SUBJECT: Forwards draft responses to Reactor Sys Branch questions which will be discussed during 800821 meeting. Responses to Questions 211.201, 211.266, 211.267, 211.268 & 211.269 will be provided on 800821. *See Report*

SUSQUEHANNA STEAM ELECTRIC STATION  
RESPONSES TO REACTOR SYSTEMS BRANCH QUESTIONS  
ER 100450 FILE 841-2  
PLA 518

Attached are PP&L's draft responses to the Reactor Systems Branch questions which will be discussed during the meeting on August 21, 1980.

FIGURE 5.1-3a

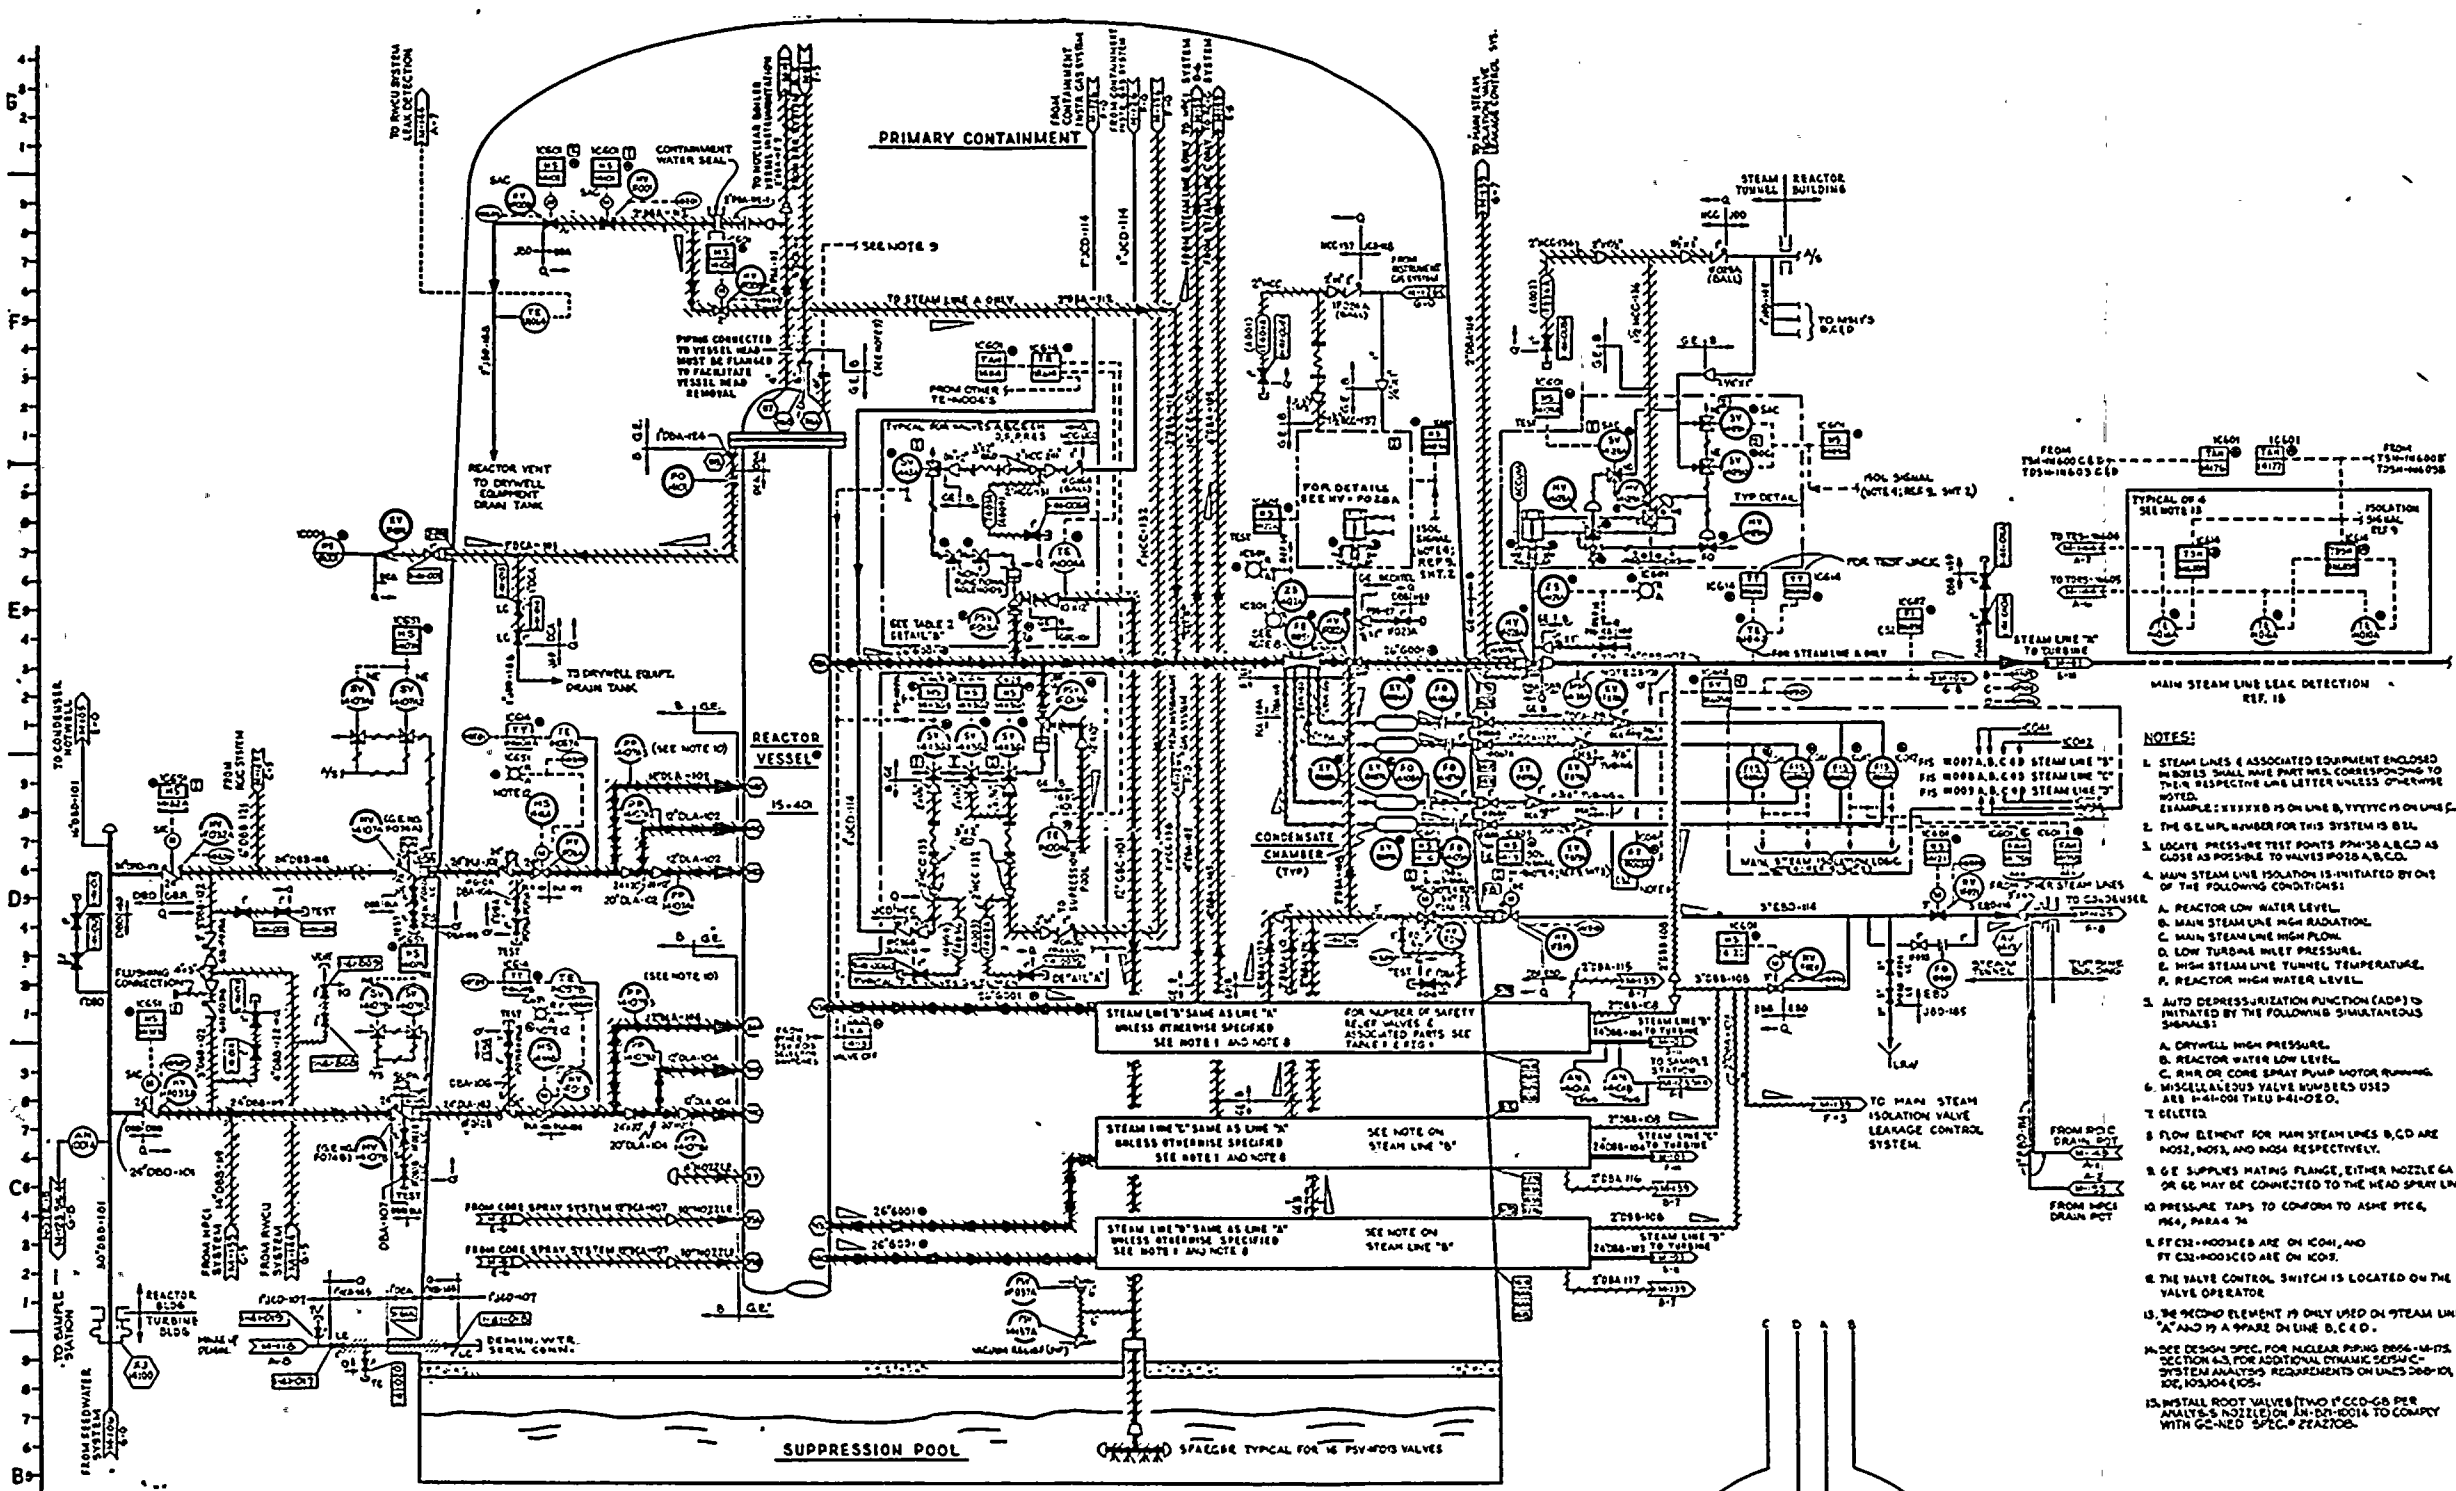
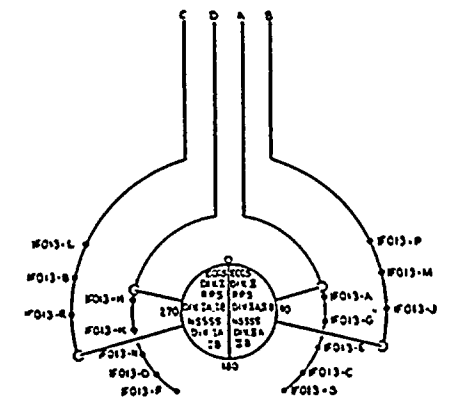
Nominal spring mode safety/relief valve setpoints are given in Table 5.2-2 and again in Table 1 of Figure 5.1-3a. The lowest setpoint in Table 5.2-2 is given as 1146 psig whereas in Figure 5.1-3a it is shown to be 1130 psig. Resolve this inconsistency. Also, what is the basis for the pressure setpoint increments between groups?

The safety/relief valve spring set pressure of 1146 psig in Table 5.2-2 is the correct value for this parameter. Figure 5.1.3a has been corrected.

FIGURE 6.3-6A

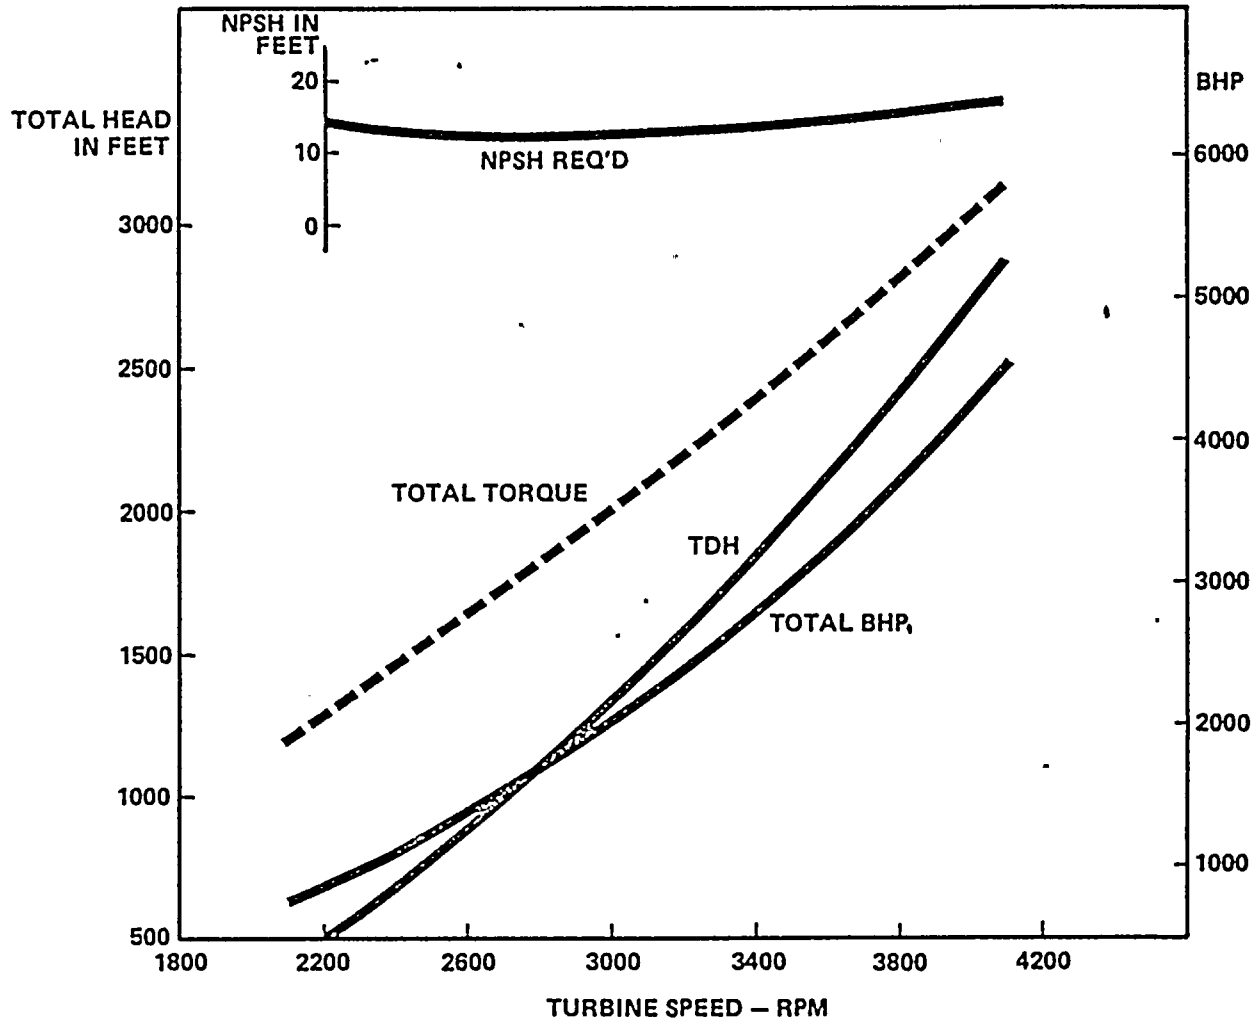
- c) Provide new Figures 6.3-3a and 6.3-6a referenced in the response to Question 211.77.

The NPSH requirements of the CS pump and the LPCI (RHR) pump are shown in Figure 6.3-6A and 5.4-15, respectively.

LOWER PLENUM ENTHALPY VERSUS TIME  
AFTER BREAK 68% DESIGN BASIS ACCI-  
DENT RECIRCULATION DISCHARGE  
BREAK, LPCI INJECTION VALVE FAIL-  
URE  
FIGURE 6.3-13

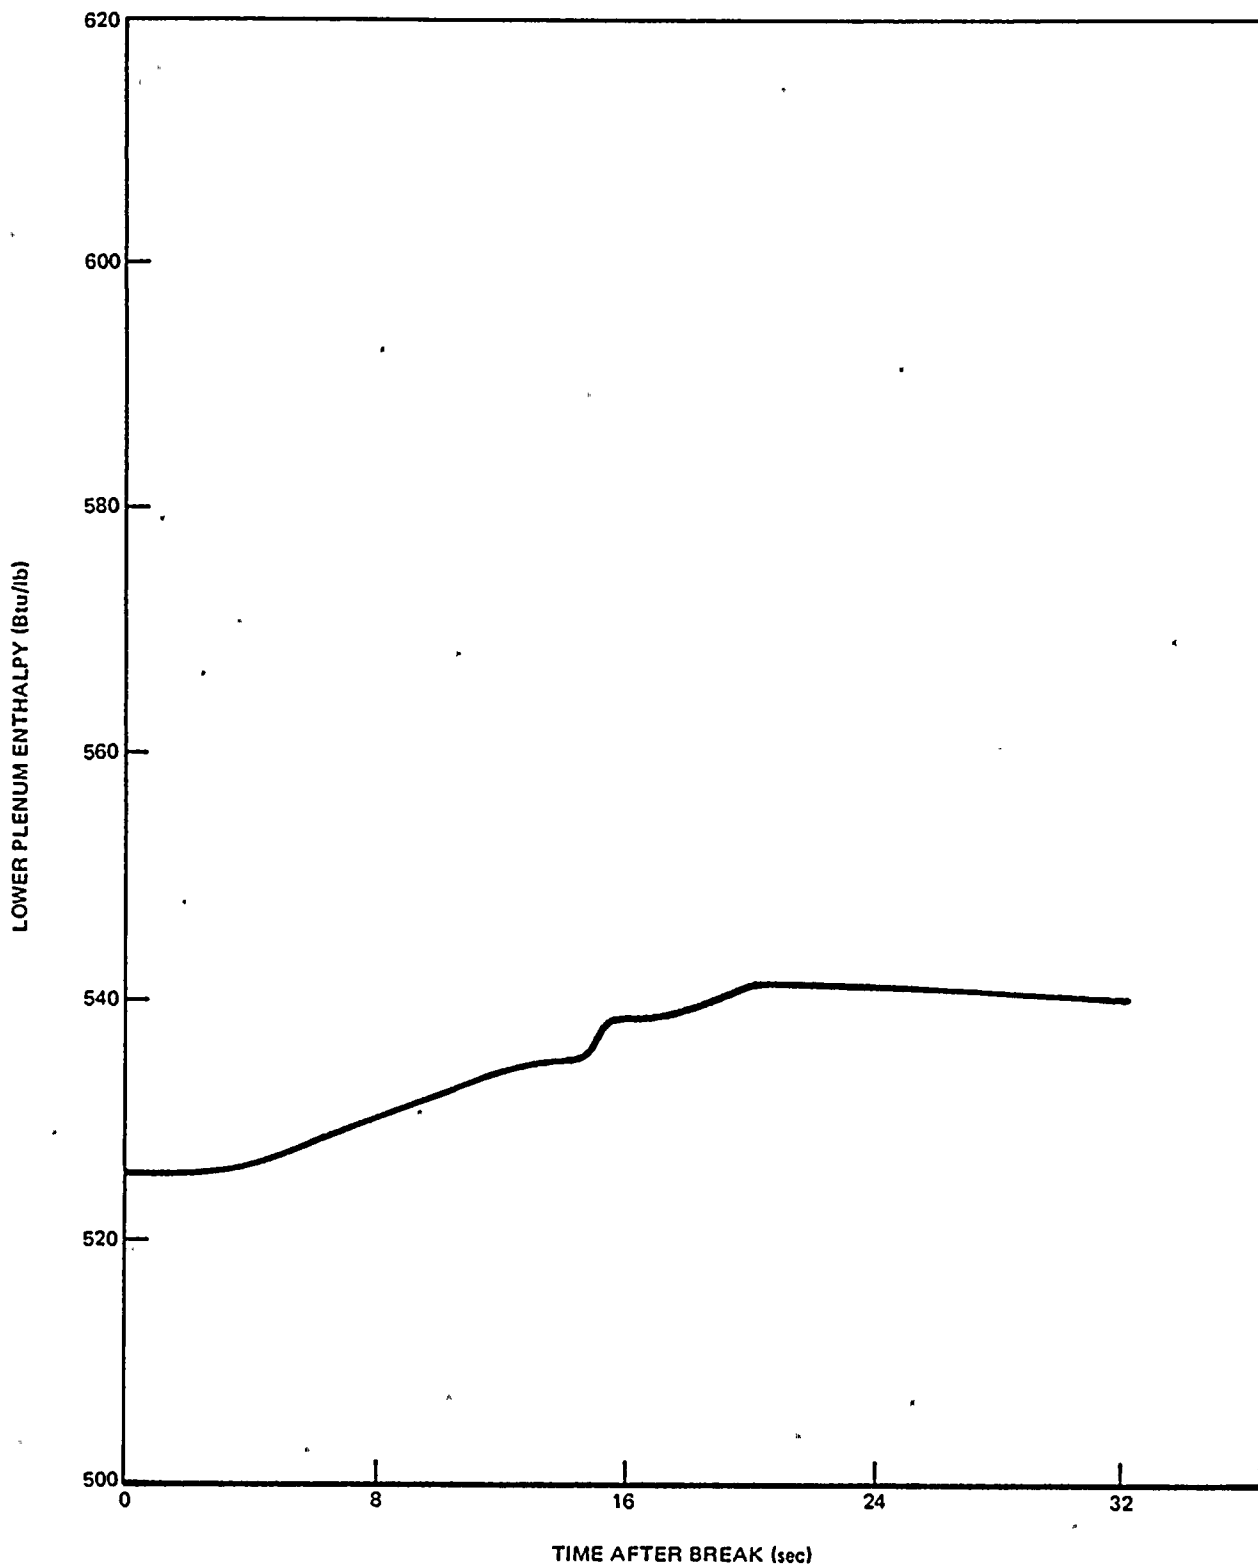
Section 6.3.3.7.3 of the PSAR states that Figure 6.3-13 is a graphical representation of the break spectrum calculations presented in Table 6.3-3. Figure 6.3-13 is a graphical representation of lower plenum enthalpy versus time. Resolve this discrepancy. The title for Figure 6.3-13 incorrectly identifies the curve as core flow versus time for the 68% DBA recirculation discharge break. Correct the title of the figure.

The reference to Figure 6.3-13 in Section 6.3.3.7.3 is incorrect. The correct figure reference is Figure 6.3-10. The title for Figure 6.3-13 has been corrected to include the figure information presented. The title of Figure 6.3-31 has been changed to read "recirculation suction break" instead of "recirculation discharge break."
